Attachment E: Supplemental Information Summary

VERTEX was asked by Beveridge & Diamond to research several other aspects of the Proposed Project. The following provides the results of this additional research:

TRACK ELEVATION EXHIBIT

RETAINING WALL LOCATION EXHIBIT

Exhibit A: Track Elevation

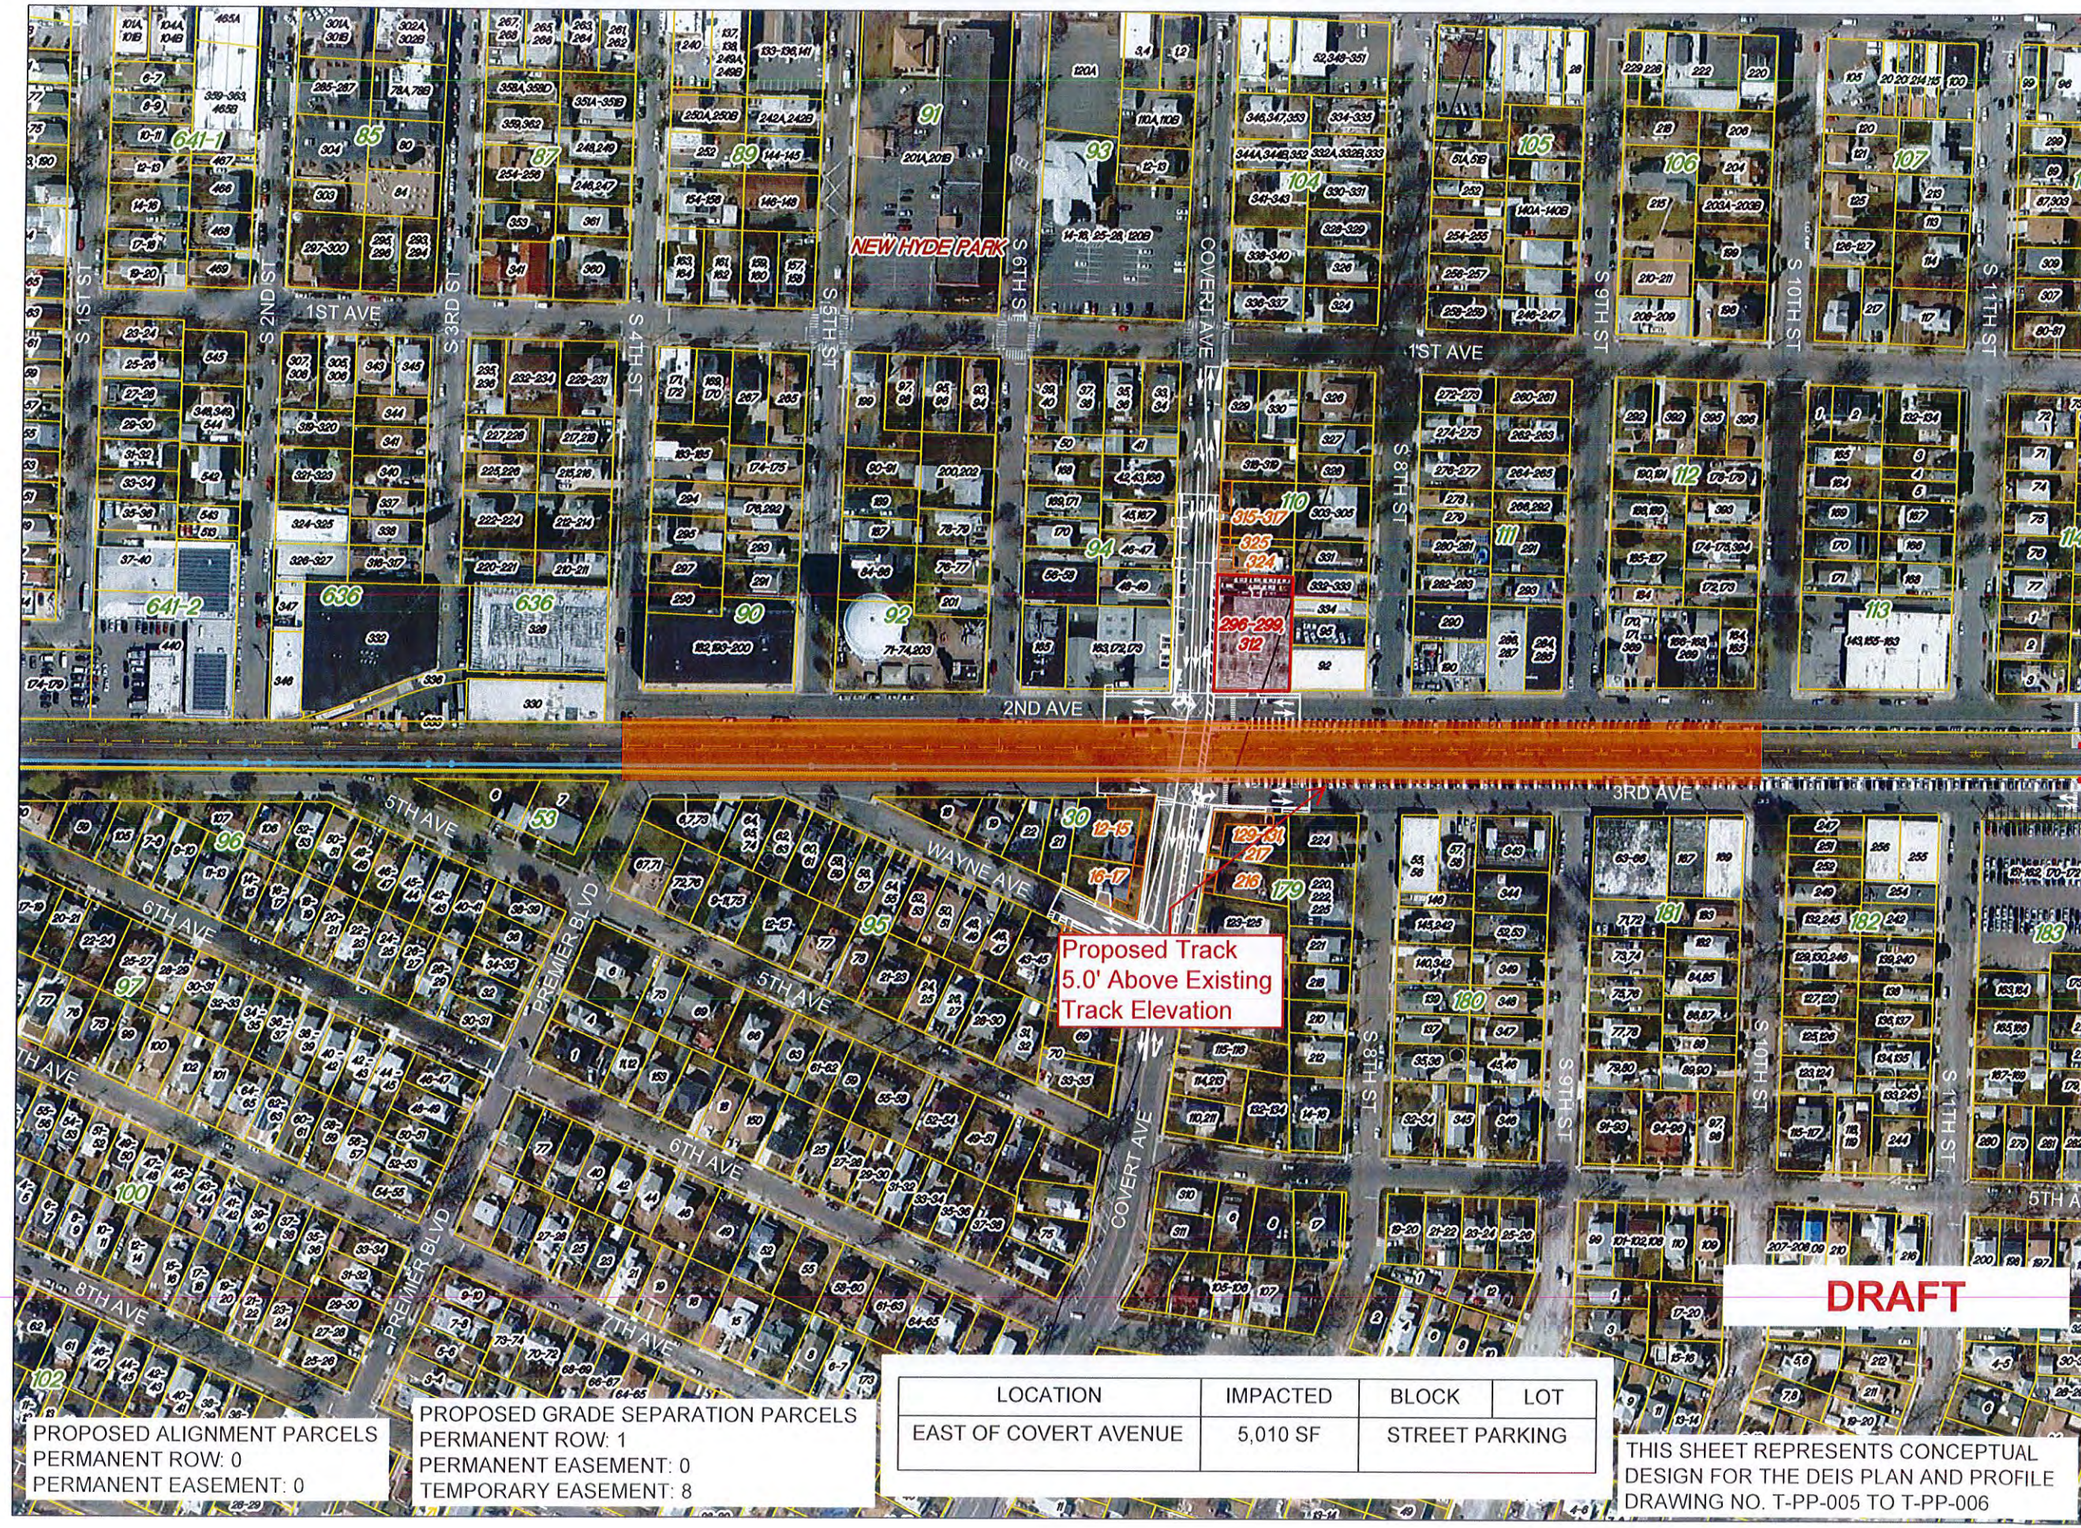
- The proposed track from Tyson Ave to Sycamore Ave will be 2.5 feet above the current track elevation.
    - The proposed track from 4th Street to 10th Street will be 5 feet above the current track elevation. It appears that this elevation increase is part of the grade separation proposed at Covert Avenue.

- A graphic representation of the raised track segments is provided in the Exhibit A at the end of this section.
  - VERTEX also reviewed where in the Study Area LIRR intends to put in retaining walls, and to the extent possible, whether the retaining wall will go right up to the ROW/property line. Based on VERTEX's review of the design plans provided in Appendix 1-A of the DEIS:

Exhibit B: Retaining Wall Exhibit

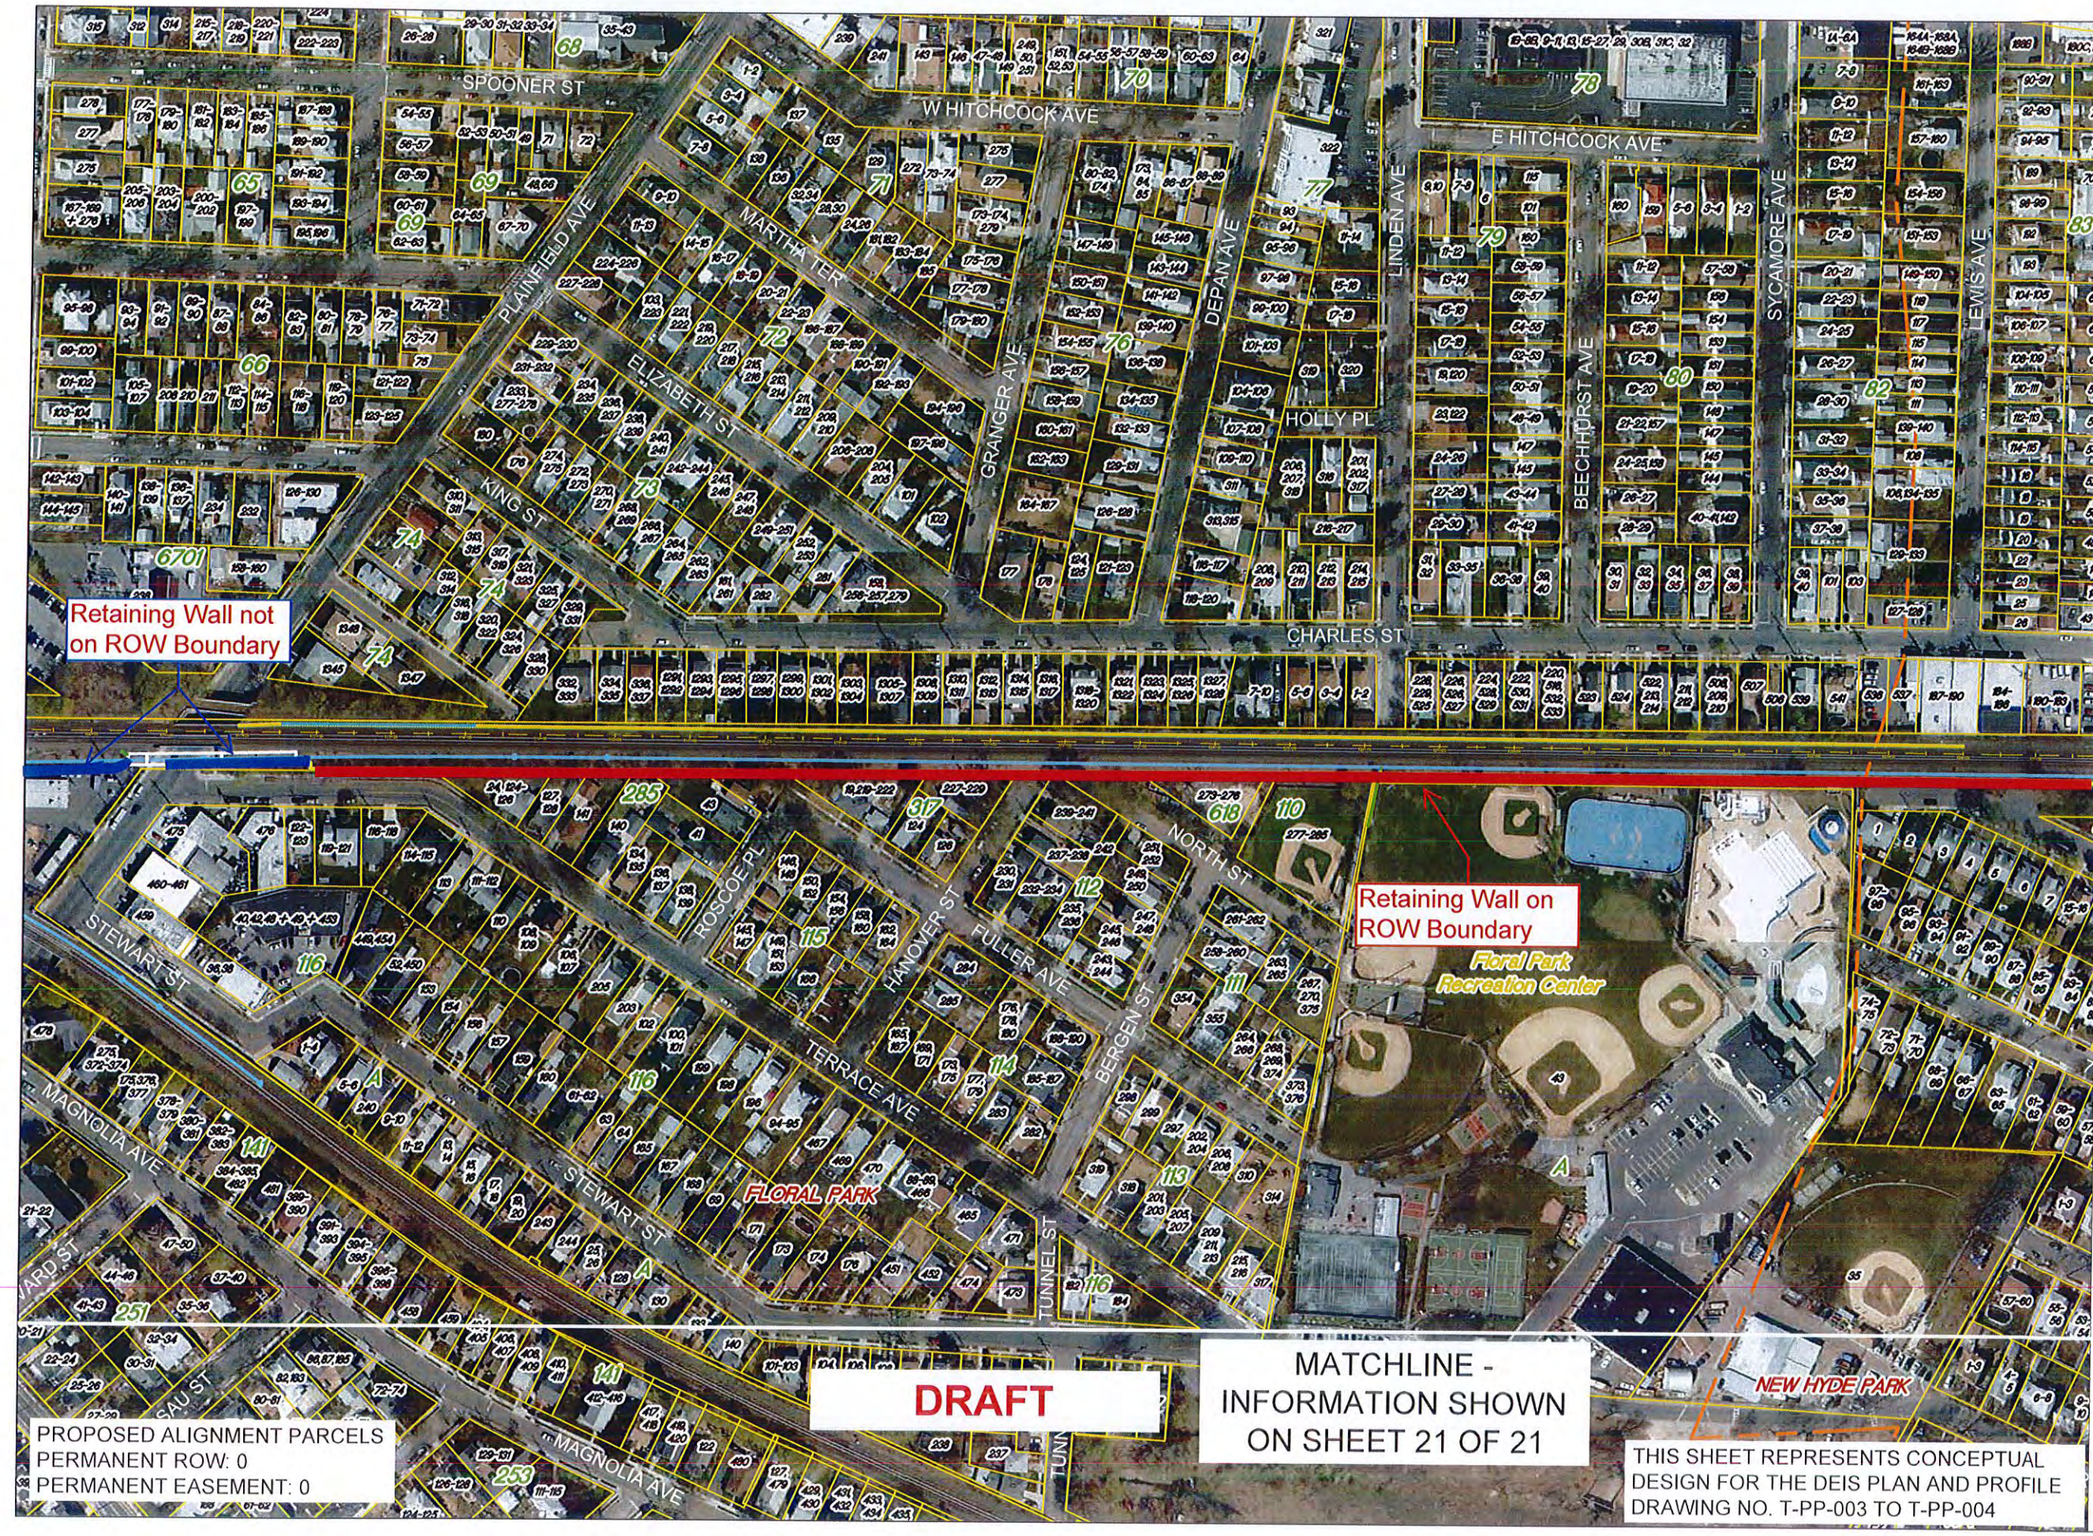
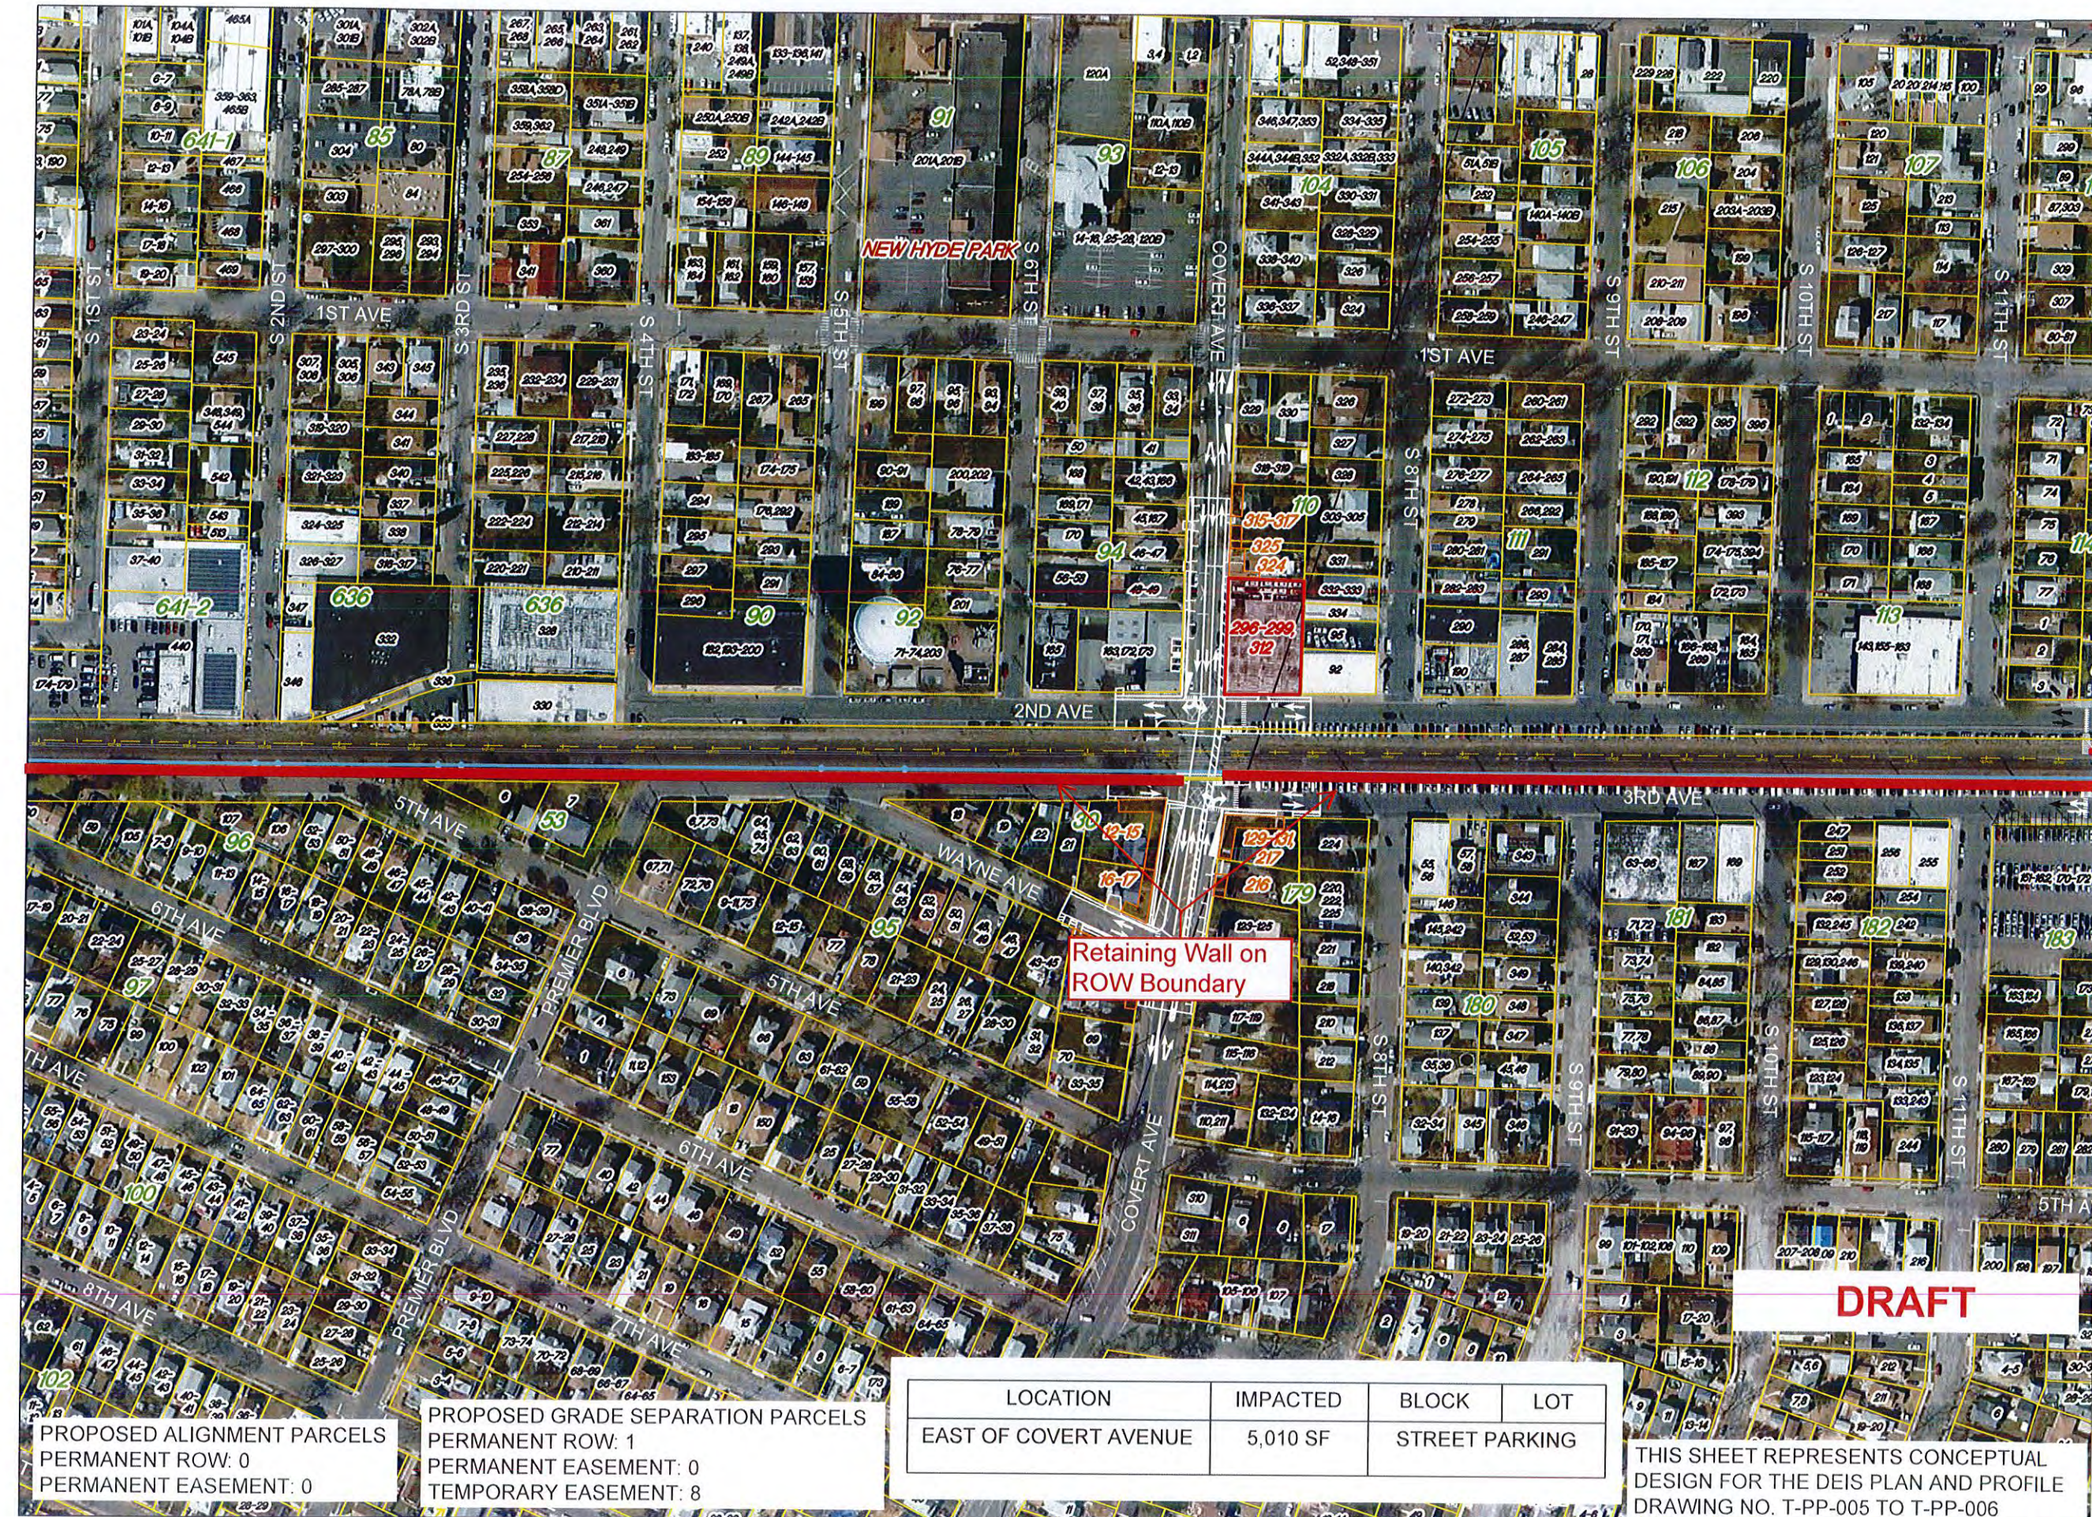
- There are retaining walls proposed nearly continuously on the southern ROW line from Plainfield Avenue to Denton Avenue.
    - There is conflicting information on whether retaining walls will be placed along the northern ROW line

- A graphic representation of the proposed retaining walls is provided in the Exhibit B at the end of this section.
